DEPARTMENT OF THE AIR FORCE  
HEADQUARTERS 542D CREW TRAINING WING (MAC)  
KIRTLAND AIR FORCE BASE, NEW MEXICO 87117 - 5000

SUBJECT: Minutes of Kirtland Air Force Base (KAFB)/New Mexico Environment Department (NMED) Meeting, 21 January 1992

1. Purpose: KAFB met with NMED to discuss the disapproval of the Battery Shop closure plan and the additional steps required to obtain NMED approval.

1 Atch  
Battery Shop Site Map

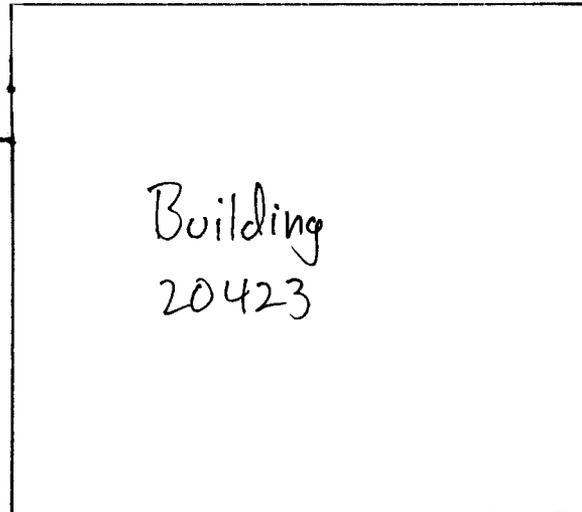
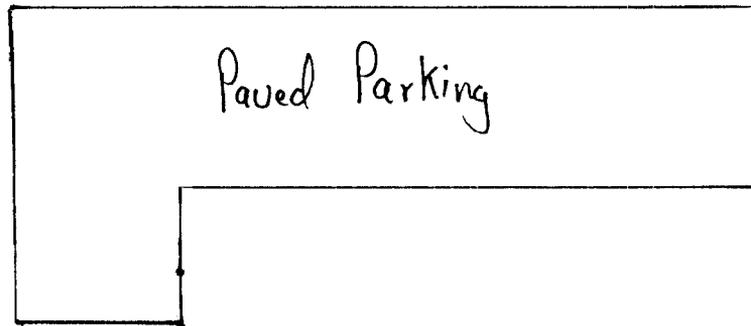
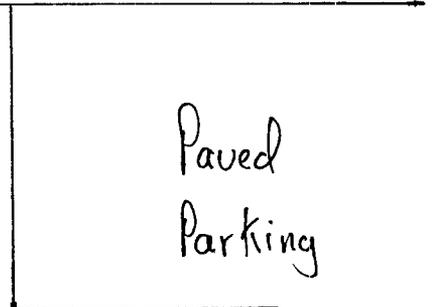
(3) Mr John Gould explained the problems with both soil gas and borings in the congested, extensively paved, building-covered Battery Shop area (see attached map).
